**REQUEST**

Current Zoning: R-5 (single family residential)  
 Proposed Zoning: UR-2(CD) (urban residential, conditional)

Approximately 0.17 acres located at the northeast corner of E. 17th Street and N. McDowell Street.  
 (Council District 1 - Egleston)

The petition proposes to develop the site to allow five single family attached dwelling units, at a density of 29.4 units per acre.

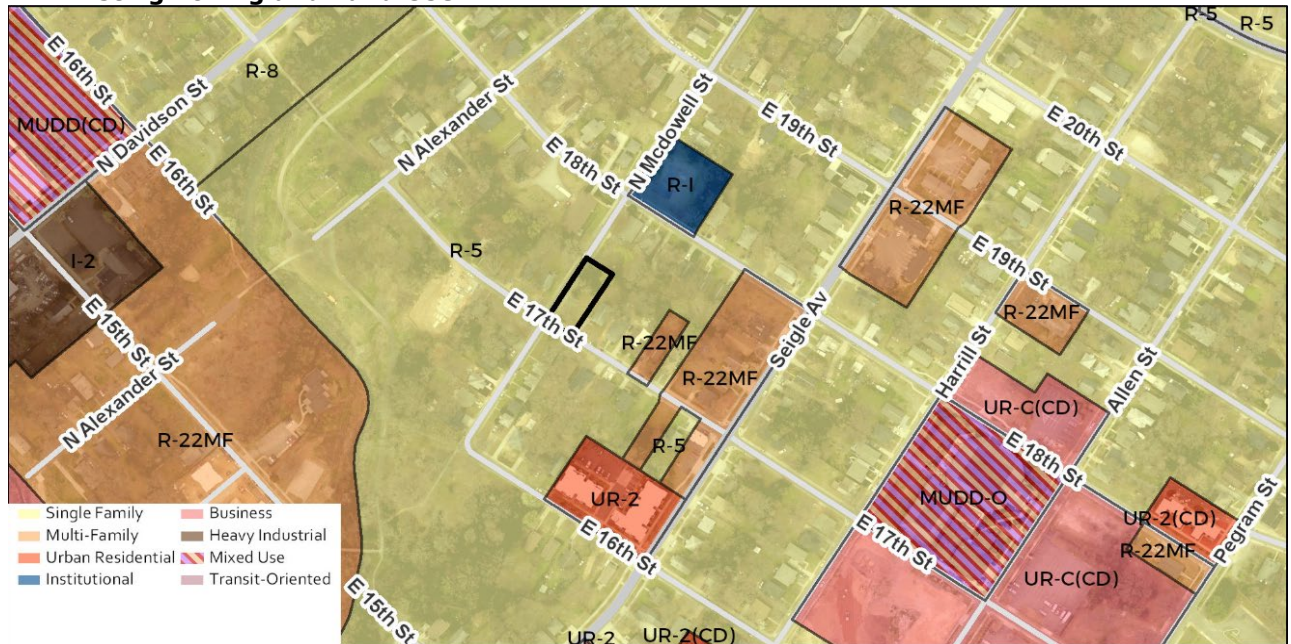
The site plan accompanying this petition contains the following provisions:

- Maximum of five single family attached dwelling units limited to 40 feet in height.
- One unit will be for-sale affordable at 80% AMI, with a 10-year restriction on resale, or shall be eligible for the in accordance with the City of Charlotte's House Charlotte program. Housing Authority's affordable housing guidelines.

- Site vehicular access via N. McDowell Street.
- Preferred building materials consisting of brick, cedar shake, wood siding, fiber cement siding, stucco, masonry and/or other material approved by the Planning Director. Permitted roof materials include asphalt shingles, composition shingles, wood shingles, tin, standing seam metal, and wood shakes.

- Minimum seven-foot sidewalk along curbside in alignment with the existing sidewalk, and an eight-foot planting strip along both E. 17<sup>th</sup> Street and N. McDowell Street. in the remaining area between the sidewalk and the property boundary. The planting strip will be increased to eight feet in width if open space is no longer required. A six-foot sidewalk along curbside and eight-foot planting strip will be provided along N. McDowell Street. In order to accommodate tree save, connections to existing sidewalk and grade of the property, the sidewalk and planting strip may be inverted, with the sidewalk located at the back of curb and the planting strip located inside of the sidewalk.

- A retaining wall may be located between the sidewalk and planting strip.
- A minimum four-foot walking space will be provided between any sidewalk obstruction and edge of curb or any adjacent retaining wall.

- Providing 429 square feet of tree save area, and 1,115 square feet of replanting area.
- Providing a site distance diagram exhibit.
